FOR PERCOLATION TESTING AND SITE EVALUATION

RE: **Perc Test Report, PROPOSED LOT 10, PROIA PROPERTY, [a re-subdivision of Clifton C. Link Property, Lot 1], receipt number A536791**

RE: Proia Property – Percolation Testing Fees

RE: Clifton C Link Property Lot 1 (resubdivision); Perc Cert comment

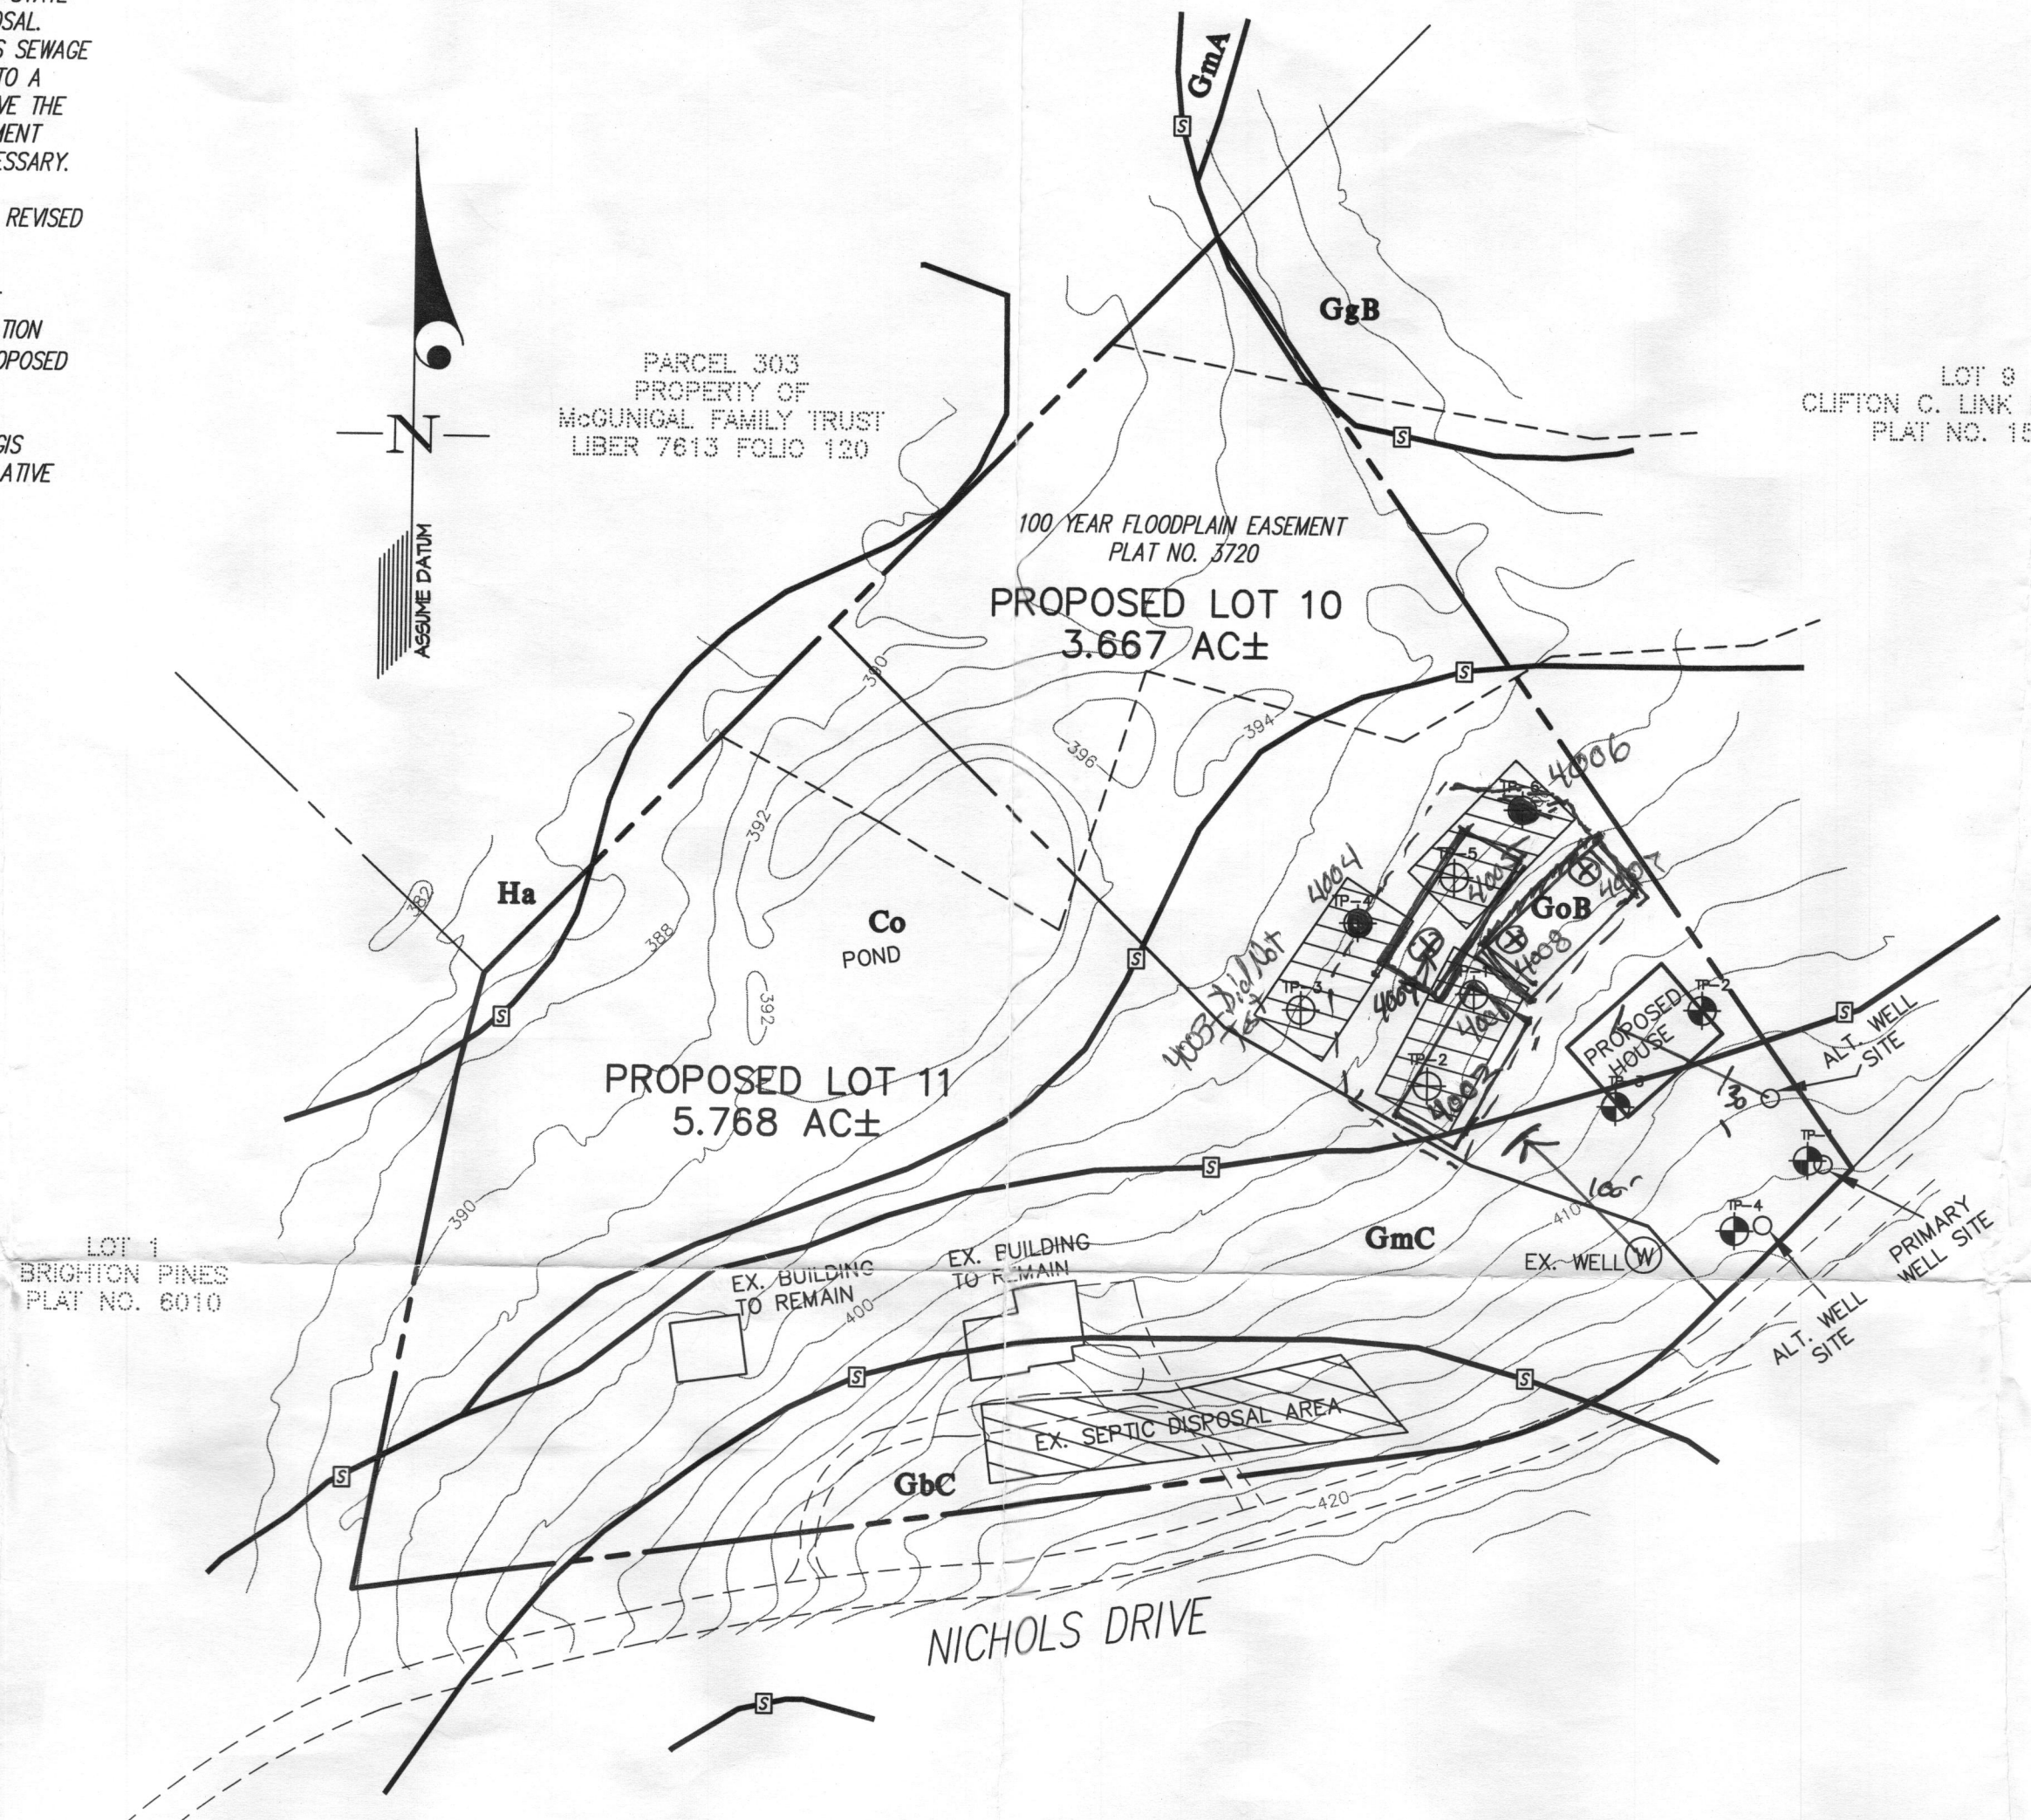
Soil conditions observed were satisfactory for onsite wastewater treatment and disposal on the proposed lot. A test location ('4009') was added to pair with location '4005' and represent a sand mound area which Passed with an infiltration rate of 40 minutes per inch. Locations 4001A and 4002 A represent a second sand mound area that Passes with an infiltration rate of 40 minutes per inch. A third sand mound area represented by locations '4007' and '4008' Passes with an infiltration rate of 24 minutes per inch.

Seasonal water table was observed at 23 inches at test location '4004', thus that location Failed. Infiltration rate greater than 60 minutes per inch occurred at location '4006'; therefore that location Failed and the proposed sand mound area represented by '4004' and '4003'(which was not tested) Failed.

For approval as a septic reserve serving the proposed lot, all three of the approvable sand mound areas are to be enclosed within a septic reserve area which will also include the area downslope of each sand mound for a distance of 25 feet. The plan showing this proposal is a Percolation Certification Plan. Other required content includes three (3) well locations or a 1500 square-foot wellbox, a building envelope 55' x 75', proposed lot line, the building restriction limits, soil map unit delineations (2008 Soil Survey of Howard County), 2-foot elevation contours and 1-foot elevation contours in the area of the proposed sand mounds.

On the proposed Lot 11 where the existing residence is located, a 10,000 square foot septic reserve is to be presented on the Percolation Certification Plan along with the existing well and two alternate well locations (or a 1500 square-foot wellbox). The footprint of the house and all other structures need to be shown on the plan. The pond and any streams or wetlands also should be shown.

The Health Department has a file for the existing property. Percolation tests were conducted in 1976 to define a septic reserve area for the residence, however soil profiles were not recorded and the Health Officer did not certify the area. To be approved, a Percolation Certification Plan that includes the area of the existing residence will have to include soil profile

descriptions that support the reserve area defined by those tests. The location of the area and the tests conducted on 1976 may be observed on the building permit proposal that is also a part of the Health Department file.
